### **NEW BRIGHTON PLANNING COMMISSION REGULAR MEETING**

**TUESDAY, APRIL 15, 2014  
7:00 P.M.**

## PLANNING REPORT

**DATE:** April 11, 2014  
**CASE:** PD2014-001, PU2014-001, LP2014-002, PL2014-001, FP2014-001  
**SUBJECT:** Consideration of a Preliminary & Final Planned Unit Development, Preliminary & Final Plat, and Site Plan for Blocks A & F within the New Brighton Exchange Redevelopment Area  
**APPLICANT:** Casey Hankinson on behalf of Ryan Companies, Inc. (Ryan) and Cardiovascular Systems, Inc. (CSI)

OVERALL SITE PLAN

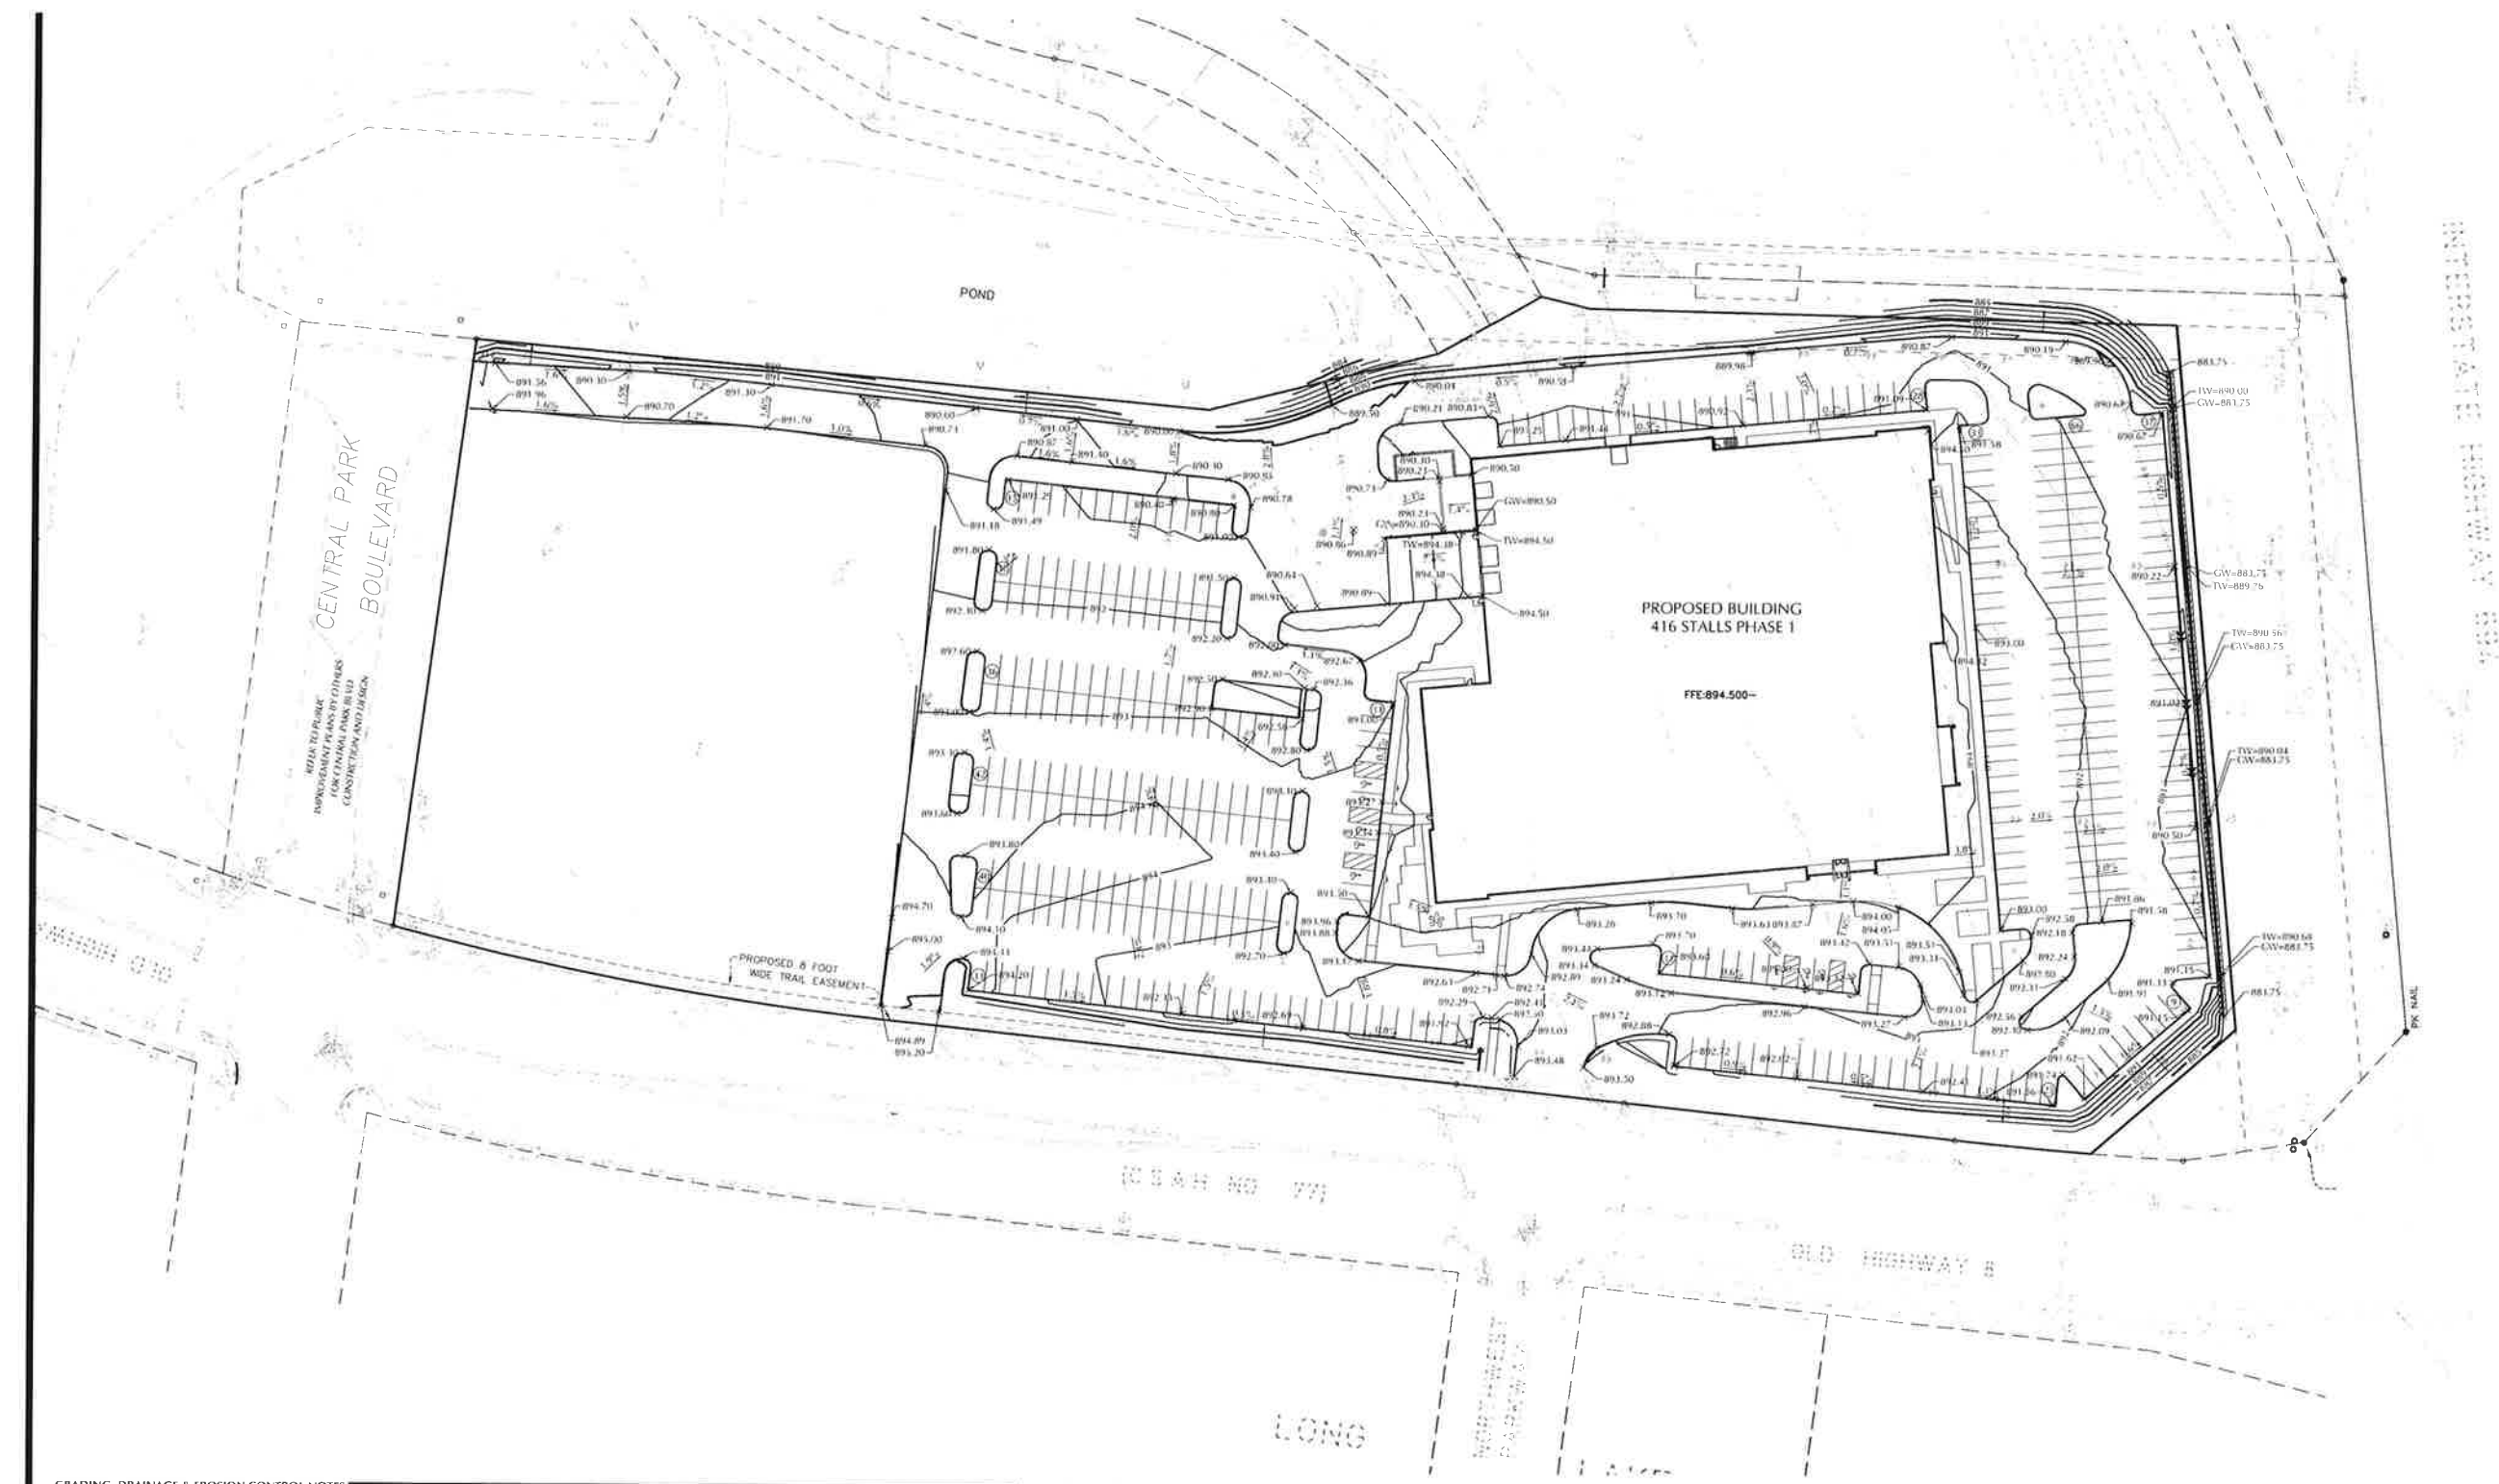
Section 6-710 (3) requires screening of parking areas that face a street frontage. The applicant's Site Plan depicts parking areas along the Old Highway 8 NW frontage. The ordinance requires screening to be a "combination of hedges, ornamental railings, walls, bollards, trees, and other methods to screen parking lots from pedestrian spaces while maintaining eye-level visibility."

The proposed Landscape Plan depicts use of deciduous shrubs planted in hedge sections 23’ in length, spaced 30’ apart, for a total of 8 hedge sections. Additionally, perimeter/boulevard trees are provided at a spacing of 25’. This plan as proposed does not provide an un-interrupted screen and the Commission may want to discuss additional screening. Staff finds the hedge section concept, intermixed with trees, incomplete and would recommend the spacing between the hedges be decreased to 15’ rather than 30’ so that no more than 2 parked cars are visible between hedge sections, rather than 3 ½ cars as currently proposed.

5. The Landscape Plan is amended to provide additional hedge screening along the parking areas abutting Old Highway 8 NW. The hedge spacing shall be decreased to 15'.
